ADDENDUM #1

SouthWest Transit 2017 Floor Repairs SOUTHWEST TRANSIT Eden Prairie, Minnesota

July 26, 2017

6 PARTIAL FIRST FLOOR PLAN

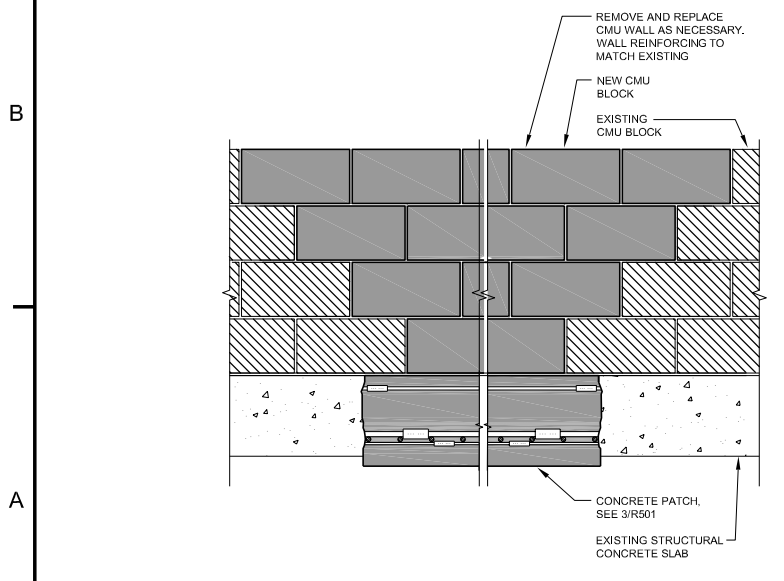
- A. Dimensions were added between gridlines and at openings.

35.1 CMU PARTIAL WALL REPLACEMENT

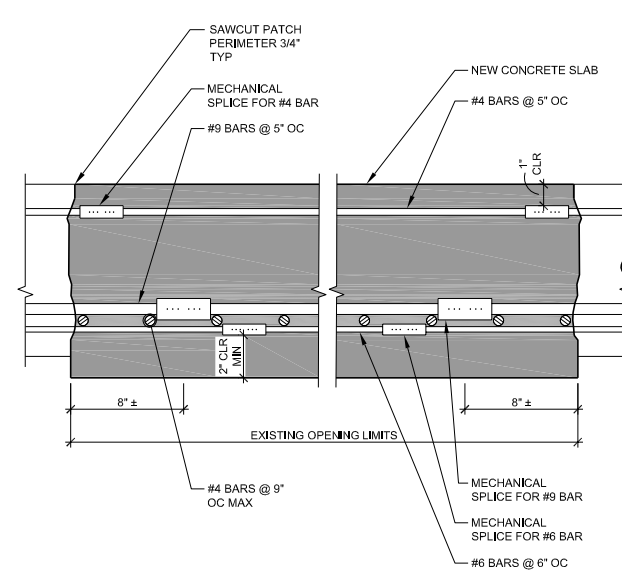
- A. Add detail for removal and replacement of CMU as necessary to perform full depth concrete repairs.

WI 35.1 CMU PARTIAL WALL REPLACEMENT

1. Work consists of furnishing all labor, materials, equipment, supervision and incidentals necessary for local CMU removal and replacement due to full depth floor repairs. Refer to Detail 35.1 for specific requirements.

1. CMU shall be $f'_m = 2,000$ PSI.
2. Mortar shall be Type S.
3. Concrete core fill for wall cells and bond beams shall be $f'_c = 3,000$ PSI.

1. Contractor shall locate and mark all CMU to be replaced. Engineer/Architect shall verify replacement locations prior to start of Work.
2. Contractor shall remove all CMU as required to complete full depth concrete repairs.
3. New CMU shall be reinforced to match existing. Provide new dowels to floor as necessary.
4. Core-fill CMU wall to match existing and match bond beam at top of wall with existing.
5. Prior to initial set of mortar, tool joints to match existing.
6. Allow 3 to 7 days for mortar to harden prior to cleaning.
7. Dispose of all accumulated material and leave premises in clean condition.
8. Masonry surfaces that become dirty or smeared during joint cutting and repointing of joint surfaces shall be cleaned with bristle brushes and plain water.
9. Unnecessary damage to surrounding construction shall be repaired by Contractor at no cost to Owner.
